RE: Foreshore Licence

**RE: Foreshore Licence Application for Tidal Energy Test Site in the Shannon Estuary**

**From:** Julie Fossitt [<mailto:Julie.Fossitt@chg.gov.ie>]  
**Sent:** 14 February 2018 14:43  
**To:** [caroline@aquafact.ie](mailto:caroline@aquafact.ie)  
**Cc:** Manager Dau  
**Subject:** Tidal device in the Fergus Estuary - G Pre00024/2018

**POTENTIAL TIDAL ENERGY DEMONSTRATION SITE ON THE SHANNON ESTUARY**

Proposed Foreshore Licence Area

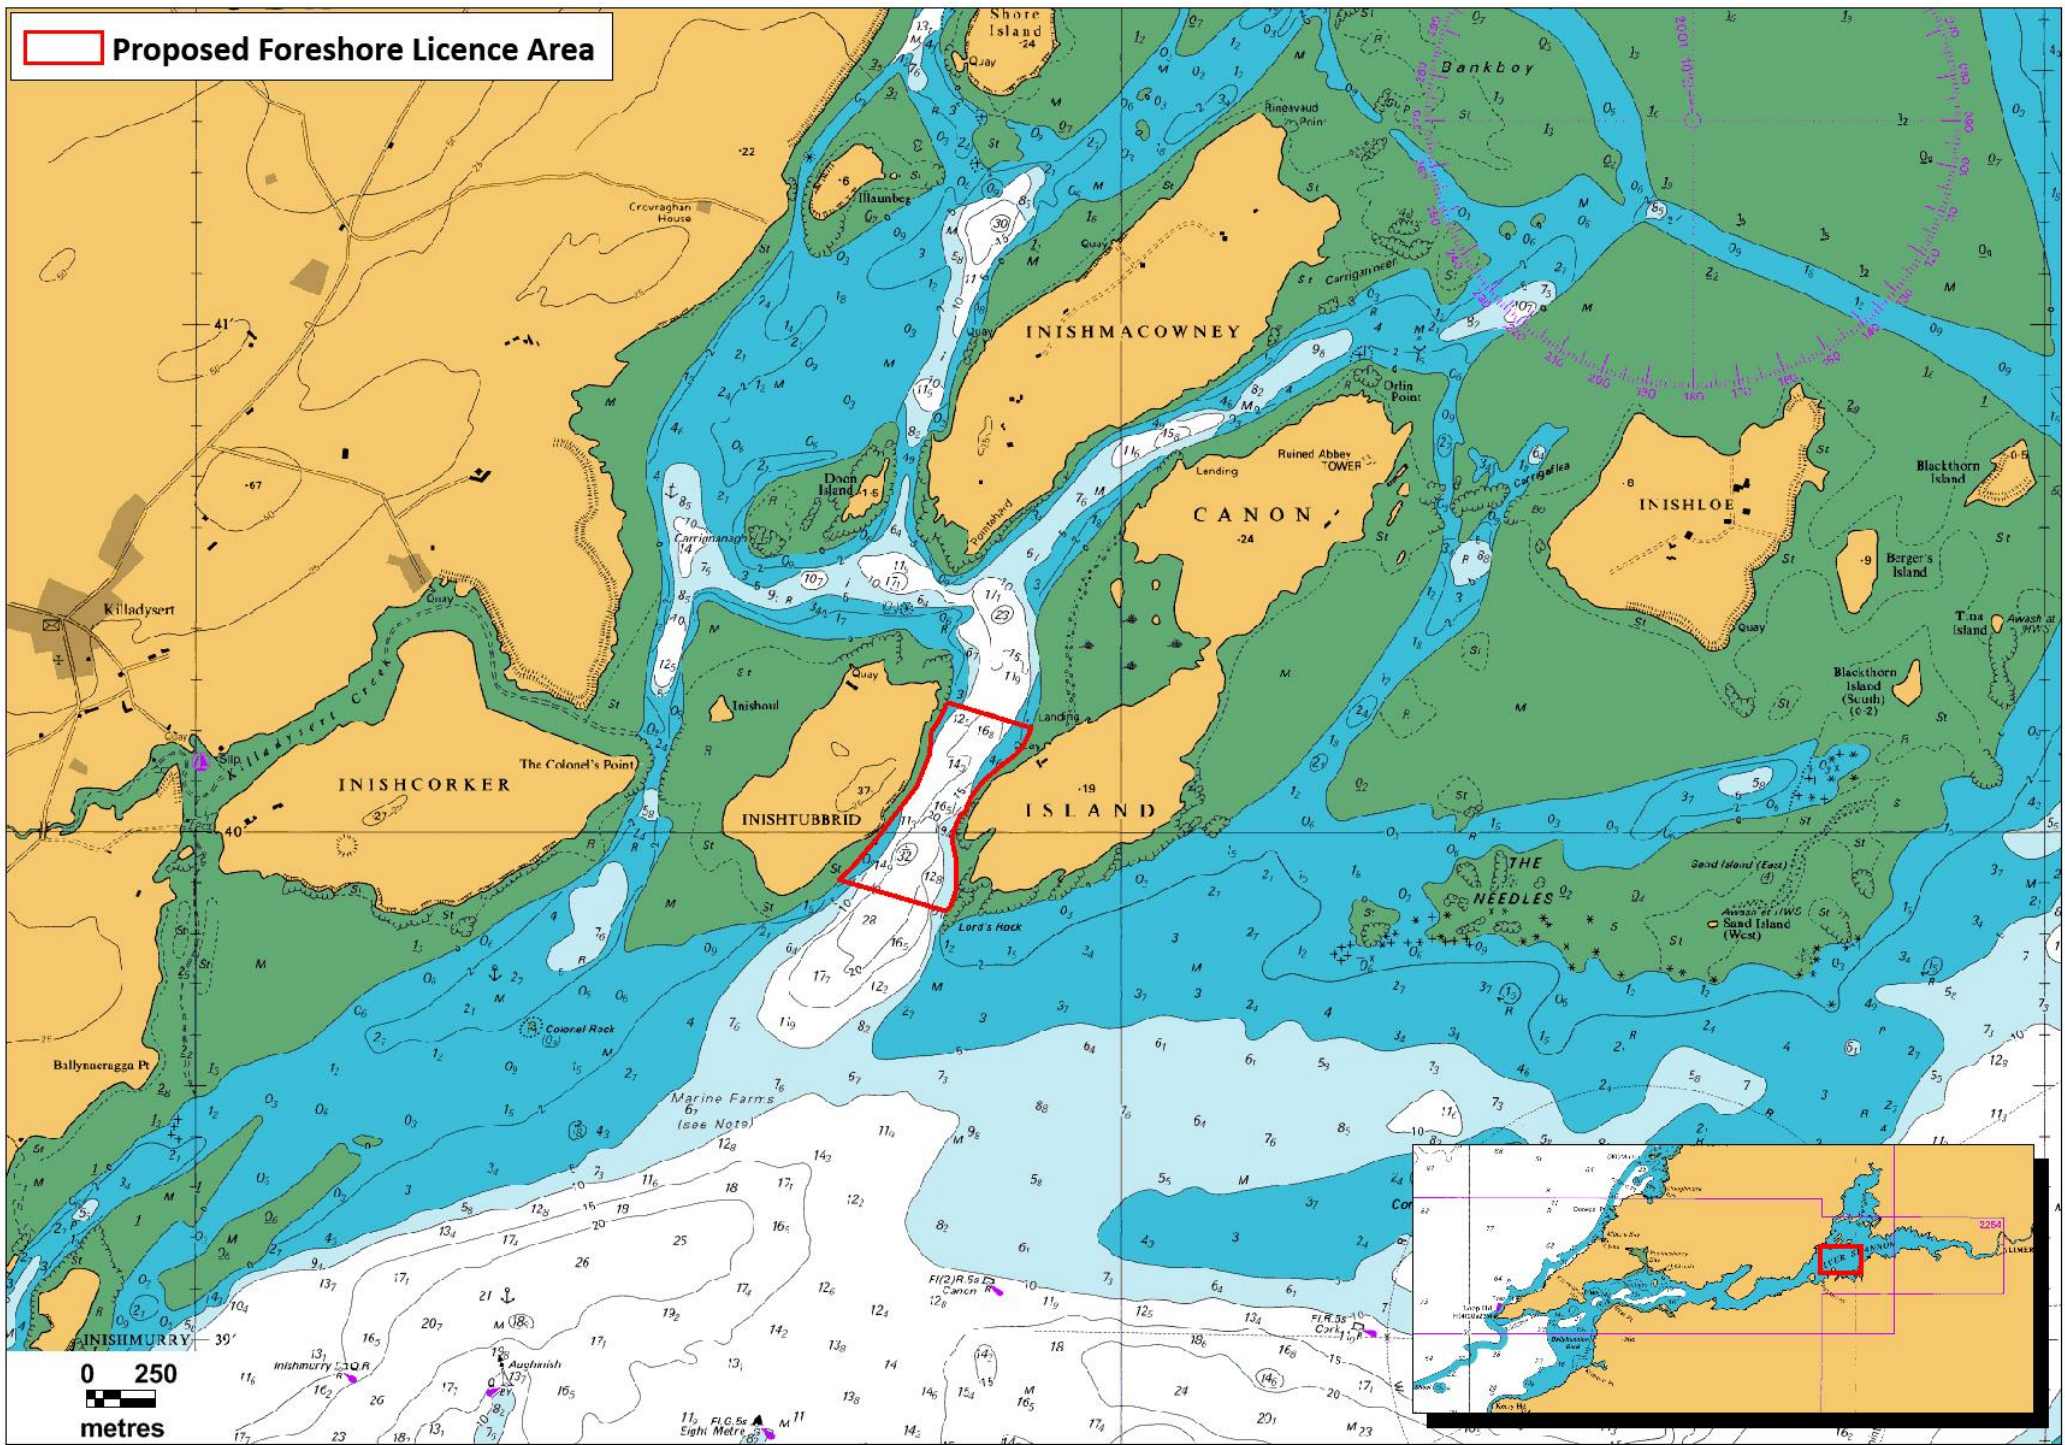
I refer to your recent scoping request concerning the development/deployment of a test tidal device in the Fergus Estuary, and within the European sites, Lower River Shannon SAC (site code 002165) and River Shannon and River Fergus Estuaries SPA (004077).

As you may not be aware, the proposed location is within the plan area of the Strategic Integrated Framework Plan (SIFP) for the Shannon Estuary, which has been given effect by Clare County Council as part of Clare County Development Plan. The current proposal appears to come within the remit of the SIFP by virtue of its location, the type of activity (tidal energy generation, albeit on a test basis), and the involvement of the Council. The location, however, is not an 'area of opportunity' site for tidal energy within the SIFP. At this early stage, it would be advised to confirm with the Council whether the proposal is in accordance with the SIFP and, accordingly, with the County Development Plan.

You should also note that there is specified plan-level mitigation for tidal energy developments in the Shannon Estuary, and within the European sites. You are advised to consult the SIFP (section 5.6) and the associated volume of mitigation measures (volume 2) to establish which apply in this case and which are of relevance to the scope of the assessments required.

When the mitigation measures have been reviewed, and the Council/developer is satisfied that the proposal is consistent with the SIFP, NPWS can be consulted further about specific aspects of assessments that may be required (noting that it seems likely that AquaFact will be producing an NIS and that DHPLG will be carrying out the appropriate assessment). The case reference allocated by DAU - G Pre00024/2018 – should be quoted in all correspondence.

Many thanks for your response. I have been in contact with Sheila Downes in Clare County Council in relation to your observations which you emailed to me on the 14<sup>th</sup> February 2018.

Following consultation with Clare County Council and an analysis of the proposal against the objectives and mitigation measures of the SIFP we are satisfied that the proposal is consistent with the ethos and requirements of the SIFP.
